Stage 1 Road Safety Audit

Project: Land North of Camer Road, Meopham

Project No/Ref: 311027-01
Document Status: First Issue

Doc Ref: 311027-01 – Land North of Camer Road, Meopham RSA1

Appendix A Problem Locations

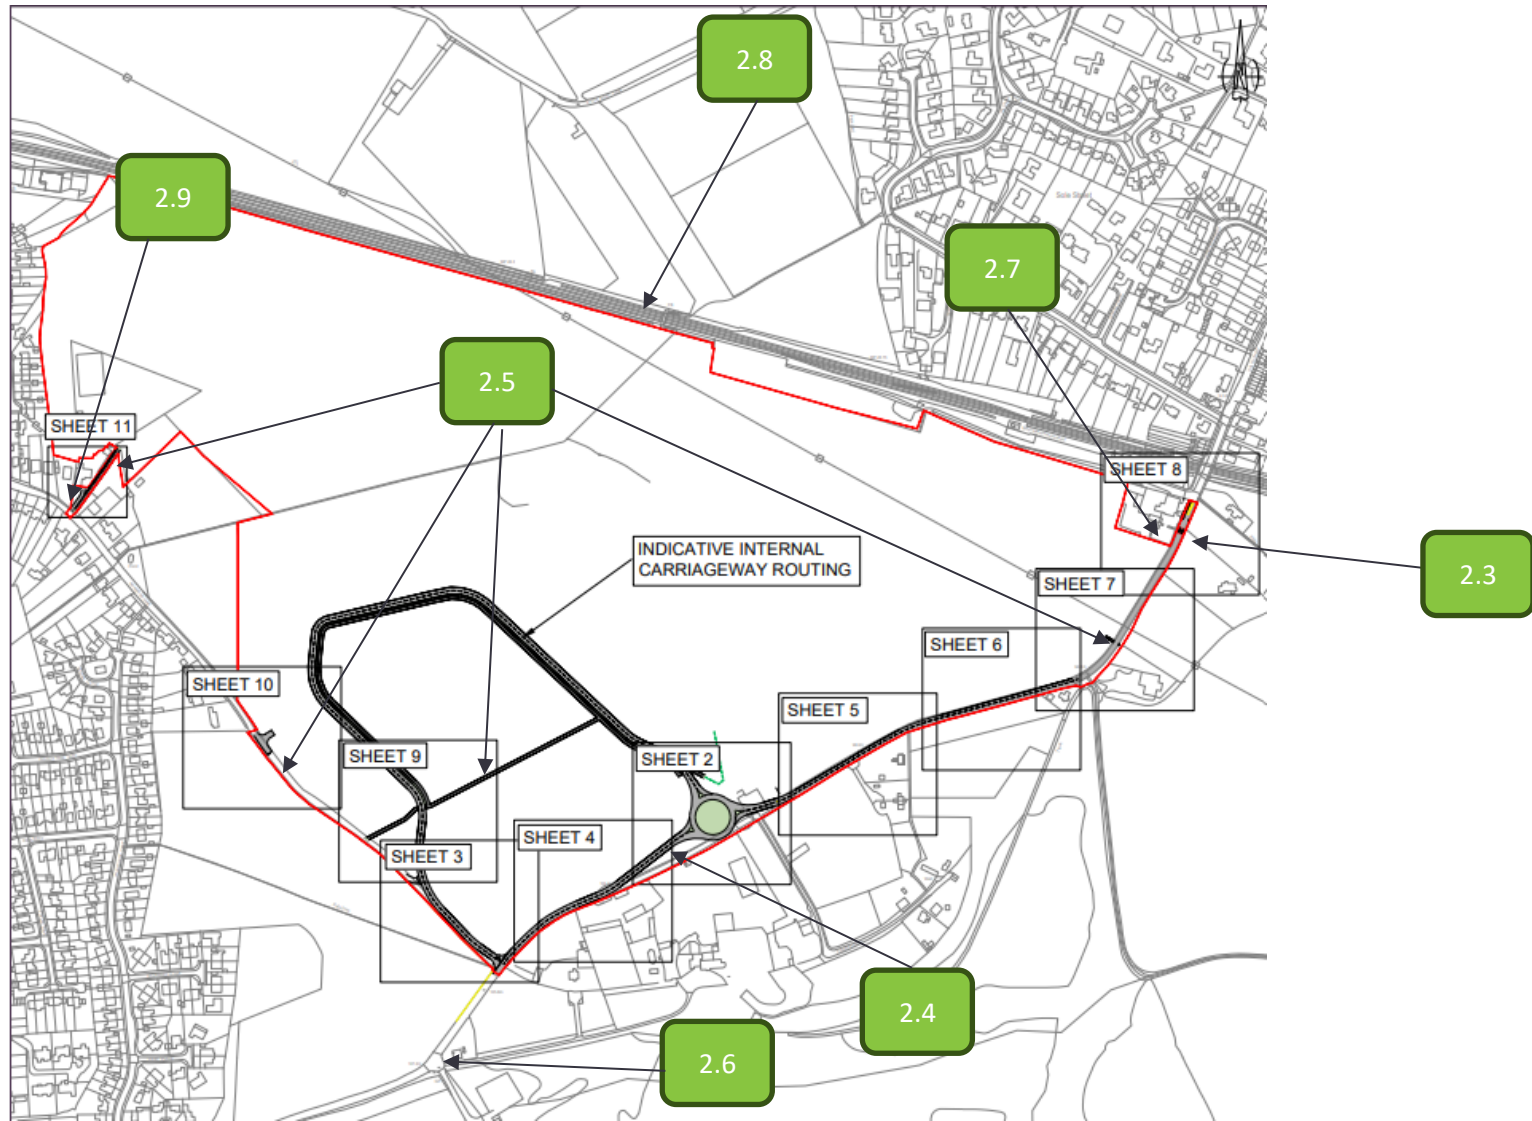
Summary: Potential collisions due to standing water or service covers

Location: Throughout

Observations during the site visit noted localised ponding along Camer Road although it is acknowledged that a significant period of prolonged rainfall has occurred. No detailed information has been provided regarding surface water drainage or associated services, and it is therefore not possible to determine whether the proposed development will give rise to safety implications. However, inadequate drainage provision could lead to the accumulation of surface water on the carriageway which may increase the risk of loss-of-control collisions.

Recommendation: Ensure that surface water drainage is provided at the detailed design stage, if necessary, provide additional drainage to mitigate the risk of localised flooding.

2.2 Problem

Summary: Potential vehicle collisions due to inadequate road space during construction stage

Location: Throughout

No details have been provided on how construction traffic will access the site and/or managed, especially prior to the widening works along Camer Road. Insufficient carriageway space may increase the risk of collision between opposing construction vehicles simultaneously travelling along Camer Road. The road safety is further compromised by the absence of a construction traffic management plan which may result in a greater conflict between construction road users.

Recommendation: Ensure that construction management plan is provided, in any event vehicle swept path assessments should be undertaken ensuring the construction vehicles can access the site safely, if necessary, provide additional widening along Camer Road.

2.3 Problem

Summary: Potential collisions due to inappropriate speeds

Location: Camer Road

Camer Road is currently subject to the national speed limit, with proposals to reduce the limit to 30mph between Sole Street and Green Lane as part of the highway works. Existing 85th percentile speed data indicates that vehicles already travel at significantly lower speeds than the posted national limit, most likely due to the narrow nature of Camer Road that acts as a natural deterrent to higher speeds.

However, the proposed widening works may encourage higher vehicle speeds despite the proposal to reduced posted limit. Beyond the speed sign and road markings at Sole Street, there appears to be no other indication of reduction in speed limit nor measures to implement the 30mph speed limit. There is the risk that vehicles may travel faster as a result of the road widening and the lack of repeater signs or speed calming measures. This may result in a head on collision with another vehicle or loss of control of vehicle due to inappropriate speeds.

Recommendation: Ensure that additional measures to control traffic speeds on Camer Road are provided.

2.4 Problem

Summary: Potential risk of side swipe collisions due to lack of deflection and loss of control collisions.

Location: Western approach to the roundabout access on Camer Road

The proposed layout of the development access roundabout access results in a straight alignment from Camer Road west to Camer Road east. There is concern that insufficient deflection may result in vehicles not slowing down on the approaches to the roundabout to negotiate the roundabout. Subsequently, this could result in loss of control collisions or collisions associated with failing to give way to other road users on the roundabout.

Recommendation: Ensure that the proposed development roundabout provides suitable deflection to mitigate the risk of failing to give way or loss of control collisions occurring on/at the roundabout.

2.5 Problem

Summary: Potential risk of collision between active travel users and vehicles.

Location: Active travel routes

It is unclear from the information contained within the active travel route design drawings where footways and cycleways are intended to be segregated or shared with other users. For example, although the emergency access along Norwood Lane is restricted by bollards, it may not be apparent to pedestrians or cyclists that emergency vehicles are permitted to use this route. This lack of clarity could increase the risk of pedestrians or cyclists being struck by an emergency vehicle. In addition, several shared foot/cycleways are not denoted by corduroy tactile paving or appropriate signage, which may heighten the risk of collisions between pedestrians and cyclists using the facility

Recommendation: Ensure that appropriate tactile paving and signs are provided to inform users of layout and operation of the facility along the proposed active travel routes.

2.6 Problem

Summary: Potential collisions associated with increased traffic flows.

Location: Camer Road / Camer Park Road

It is acknowledged that the current layout of the Camer Road / Camer Park Road junction is constrained in terms of visibility, but at present it operates with relatively low traffic volumes. However, the proposed scale of development will significantly increase traffic movements along Camer Road. This raises concern that the higher traffic volumes on the major arm of the junction will exacerbate existing safety issues. In particular, vehicles exiting from Camer Park Road with limited visibility may be forced into the path of oncoming traffic generated by the development, thereby increasing the likelihood of collisions.

Recommendation: Ensure that appropriate traffic analysis is undertaken at this junction and provide improvements to visibility at this junction.

2.7 Problem

Summary: Potential collisions associated with increased traffic flows

Location: Camer Road / The Railway Inn access junction

It is acknowledged that the current layout of the Camer Road / Railway Inn access is constrained in terms of visibility, but at present it operates with relatively low traffic volumes. The proposed scale of development will increase traffic movements along Camer Road, raising concern that the higher traffic volumes on the major arm of the junction will exacerbate existing safety issues. In particular, vehicles exiting from the Railway Inn car park with limited visibility may be forced into the path of oncoming traffic associated with the site, thereby increasing the likelihood of collisions.

Although a convex mirror is provided at this access, it is considered insufficient. During the site visit, vehicles traveling at speed down the bridge to the north of the access were observed to cause significant delays when attempting to exit the car park, further highlighting the safety risks at this location.

Recommendation: Ensure that appropriate traffic analysis is undertaken at this junction and provide improvements to visibility at this junction.

2.8 Problem

Summary: Potential safety issues associated with active travel users and rail line to the north

Location: Internal layout and rail line

The railway line to the north of the site creates a significant level of severance between the development and potential amenities located beyond it. Without adequate restraint systems, there is a risk that pedestrians or cyclists may attempt to cross the rail line if it provides a quicker or more convenient desire line. Given the scale of the proposed development, it is essential that active travel routes within the site are comprehensive and well-connected to local amenities. This will help to discourage residents from attempting to cross the railway line at informal or unsafe points, thereby reducing the risk of serious incidents.

Recommendation: Ensure that the pedestrian/cycle routes provide safe connectivity to local amenities, where necessary suitable restraint systems should be provided between the site and the rail line.

2.9 Problem

Summary: Potential risk of active travel users being struck by residential traffic.

Location: Pedestrian access (Drawing 211206-09 Rev A Sheet 11)

The proposed pedestrian/cycle link is proposed via an existing driveway which will be relocated to the west; the drawings show no barrier or form of delineation between the driveway and the proposed active travel connection. Consequently, there is a greater risk that pedestrian or cyclists could be struck when using the path and a vehicle is emerging from the driveway simultaneously. There are also no corduroy tactiles to denote the start and end of the shared pedestrian and cycle route.

Recommendation: Provide sufficient delineation between the driveway and the foot/cycleway ensuring that appropriate corduroy paving and signs are provided to denote the shared use facility.

Issue N°	RSA Problem	RSA Recommendation	Design Organisation Response	Overseeing Organisation Response	Agreed RSA Action
2.1	Potential collisions due to standing water or service covers	Ensure that surface water drainage is provided at the detailed design stage, if necessary, provide additional drainage to mitigate the risk of localised flooding	The proposed drainage strategy will be confirmed and provided during the detailed design phase to ensure that the new highway infrastructure is adequately designed in accordance with relevant design guidance

2.2	Potential vehicle collisions due to inadequate road space during construction stage	Ensure that construction management plan is provided, in any event vehicle swept path assessments should be undertaken ensuring the construction vehicles can access the site safely, if necessary, provide additional widening along Camer Road	A detailed Construction Traffic Management Plan is anticipated to form a Condition of a successful application and would be developed, in collaboration with the appointed contractor, to ensure the safe access and movement of construction vehicles to and from the site during the construction phases

2.3	Potential collisions due to inappropriate speeds	Ensure that additional measures to control traffic speeds on Camer Road are provided	It is considered that the existing alignment of Camer Road will retain lower traffic speeds even with the proposed road widening especially when coupled with the introduction of a significant speed restraint feature in the form of the site access roundabout. During the detailed design stage additional speed restraint features will be explored as considered necessary and appropriate by Kent County Council as highway authority and the design team. This will be informed by on-site observations, relevant design guidance and a Stage 2 Road Safety Audit

2.4	Potential risk of side swipe collisions due to lack of deflection and loss of control collisions	Ensure that the proposed development roundabout provides suitable deflection to mitigate the risk of failing to give way or loss of control collisions occurring on/at the roundabout	The design of the site access roundabout will be confirmed and provided during the detailed design phase to ensure that the new highway infrastructure is adequately designed in accordance with relevant safety and design guidance. This will be supported by a Stage 2 Road Safety Audit

2.5	Potential risk of collision between active travel users and vehicles	Ensure that appropriate tactile paving and signs are provided to inform users of layout and operation of the facility along the proposed active travel routes	Specific information regarding the usage and form of the active travel routes will be confirmed during the Reserved Matters and detailed design stages of the development. This will ensure appropriate surfacing and signage is provided in accordance with relevant design guidance. This will further be supported by a Stage 2 Road Safety Audit.

2.6	Potential collisions associated with increased traffic flows	Ensure that appropriate traffic analysis is undertaken at this junction and provide improvements to visibility at this junction	There is no history of traffic related collisions at the junction of Camer Road and Camer Park Road and the transport modelling completed as part of the Transport Assessment did not identify any capacity constraints at this junction. The junction is signed in both directions for traffic on the mainline and the speed limit is proposed to be reduced, decreasing potential stopping distances.

2.7	Potential collisions associated with increased traffic flows	Ensure that appropriate traffic analysis is undertaken at this junction and provide improvements to visibility at this junction	There is no history of traffic related collisions at the junction of Camer Road and The Railway Inn. The junction is preceded by a humpback bridge to the north which is signed in both directions and is likely to reduce vehicle speeds in this specific location, decreasing potential stopping distances.

2.8	Potential safety issues associated with active travel users and rail line to the north	Ensure that the pedestrian/cycle routes provide safe connectivity to local amenities, where necessary suitable restraint systems should be provided between the site and the rail line	A comprehensive network of active travel routes are proposed through the outline masterplan to ensure viable options are provided in all directions for site users. Furthermore, an existing rail overbridge is provided to the north of the site facilitating the safe passage of pedestrians across the rail line

2.9	Potential risk of active travel users being struck by residential traffic	Provide sufficient delineation between the driveway and the foot/cycleway ensuring that appropriate corduroy paving and signs are provided to denote the shared use facility	During the detailed design stage the specific segregation provisions between the existing driveway and proposed active travel corridor will be provided to ensure the risk of conflict in this location is minimised
